*Mixed Oxide Fuel Fabrication Facility
Construction Authorization Request
Responses to NRC Request for Additional Information*

**TYPICAL SCHEMATIC USING SIPHON AND AIR-JET LIFT FOR FLUID
TRANSFER USING SEPARATION POT**

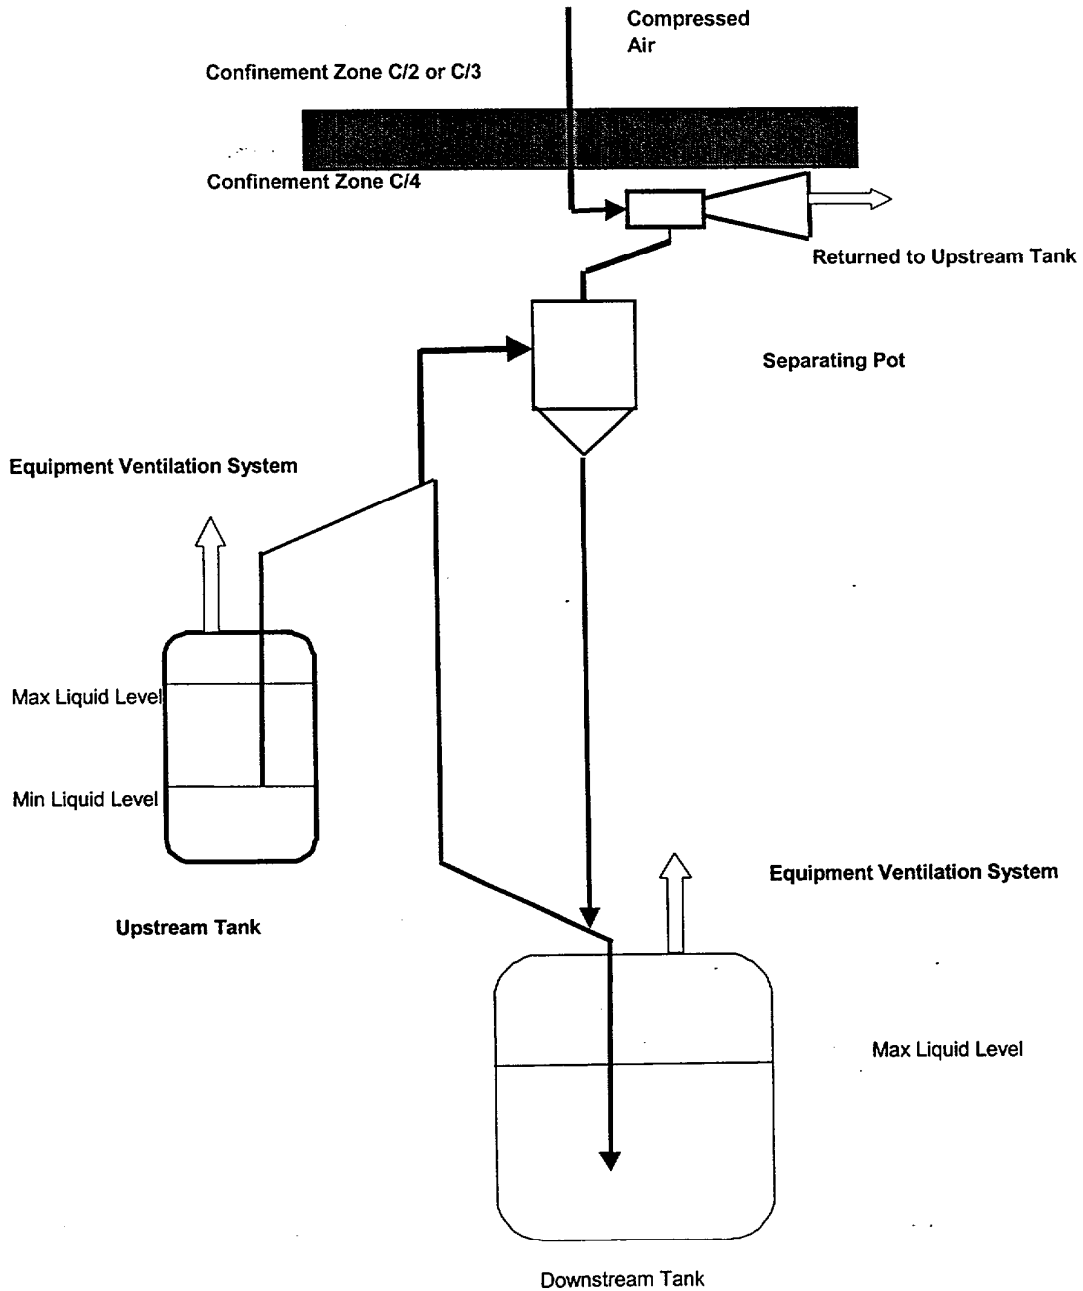
Component isolation in the event of an earthquake

MFFF process systems are shut down in the event that earthquake conditions are detected. This is achieved by the following:

- Air and steam supplies that provide process fluid motive force are isolated by means of the redundant isolation valves described above.
- Process prime movers powered by normal electrical power are stopped. Those electrical loads requiring power for safe process shutdown are supplied with the emergency uninterrupted power.
- Fluid transport system components handling radioactive materials are designed for the design basis earthquake. In the event of system breach, liquids are collected at the bottom drip tray within the process cell or glove box and recycled through the waste treatment management units.

- Piping components handling the transfer of radiological process fluids outside of process cells and gloveboxes are double-wall jacketed construction. All piping components designated IROFS are designed to withstand design base earthquake conditions.

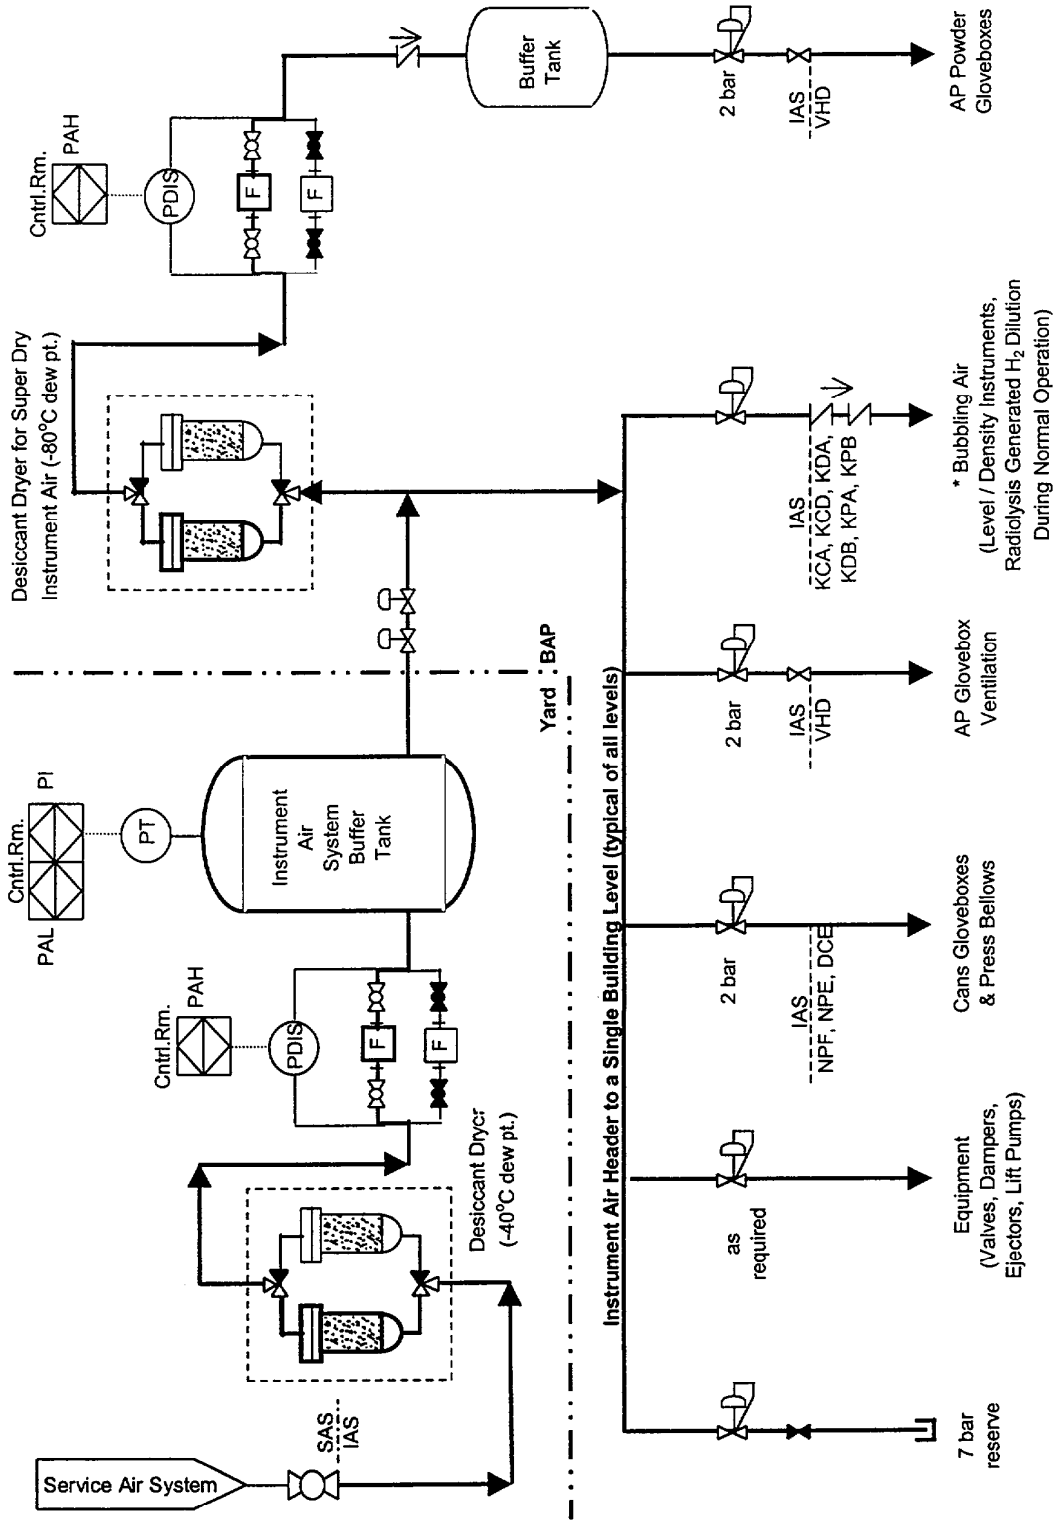
Regarding the Instrument Air System, identify any parts or functions of the system that are part of or support the "glovebox pressure controls." The system description discusses aqueous polishing glovebox scavenging and supporting miscellaneous equipment, however Figure 11.9-10 shows interfaces with MOX processing gloveboxes. Define the term "miscellaneous equipment." Section 11.9.1.10.5 of the application, "System Interfaces," only lists the Service Air System and the Seismic Detectors as interfacing systems. The general description of gloveboxes in Section 11.4.7.1.5 does not list the Instrument Air System as an interface. Please clarify the functions and all interfaces of the Instrument Air System and clarify its safety function, if any, and whether any part of this system is a primary SSC or an item relied upon for safety. Provide the basis for the basis for your conclusions. Clarify the functions and interfaces of the scavenging air system.

The system description discusses aqueous polishing glovebox scavenging and supporting miscellaneous equipment; however, Figure 11.9-10 shows interfaces with MOX processing gloveboxes. Define the term "miscellaneous equipment."

- Very High Depressurization (VHD) Exhaust System: IAS provides instrument quality air for ventilation and cooling air for sixteen (16) AP and two (2) MP gloveboxes and the MP pelletizing press bellows.
- Very High Depressurization (VHD) Exhaust System: Super dry air (-80°C dew pt.) is used for ventilation and cooling of the AP powder and electrolyzer gloveboxes.
- The I&C system uses bubbling air in all AP process units to measure level and density.

Refer to attached sketch.

* Refer to sh. 2 for the independent Emergency Scavenging Air sub-system

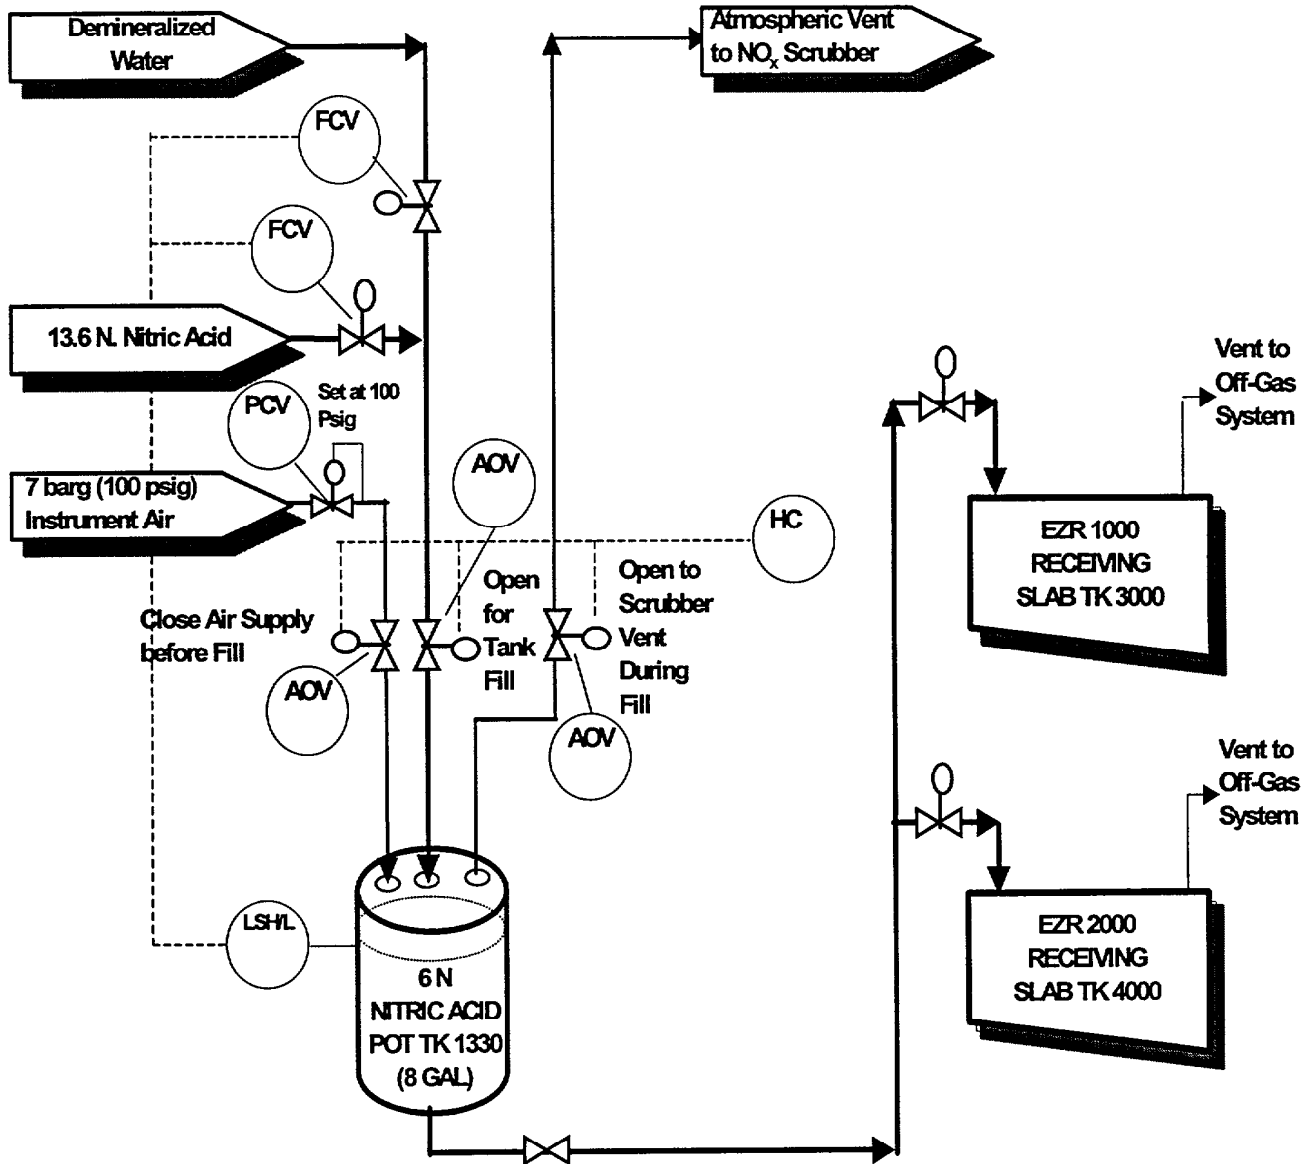
Section 11.9.3.1.2 mentions that the 6N nitric acid tank is pressurized with air. No air pressure is specified. Figure 11.9-17 displays the system's flow diagram but does not show an air supply. It is unusual to pressurize a nitric acid tank and the impacts of the tank's rupture or unanticipated flow surges through lines and valves may impact the safe handling of radioactive materials. It is not possible to make a safety determination regarding this system until additional information is provided, including the design bases and values for the system and any controls.

The electrolyzer has been designed and tested to prevent settling out of the particulates as they are dissolved; however, the slab tank is unable to maintain the particulates in suspension because of its required geometry and lack of mixing equipment. The result of this is that when the solution is returned back to the electrolyzer, many particulates may remain as residue in the bottom and on the sides of the slab tank. These must be resuspended in the smallest volume possible and transferred back to the other electrolyzer so that the particulate PuO₂ can be redissolved through normal process at the electrolyzer.

Resuspending the particulate PuO₂ requires the use of pressurized nitric acid to dislodge the particulates from the walls and bottom of the slab tank. Compressed air will be used to supply nitric acid from a dedicated nitric acid pot (see Sketch below). The pot and all connecting components will be designed for the 7 barg (100 psig) pressure condition, safely isolating the rest of the nitric acid system from the high pressure. All piping is already rated for 150 psig.

During the resuspension stage, the 100 psig nitric acid would be introduced into the tank in small amounts until, after two or three cycles of rinsing, all of the particulates are resuspended and returned to an electrolyzer. The volume is restricted due to the limited volume of the second electrolyzer.
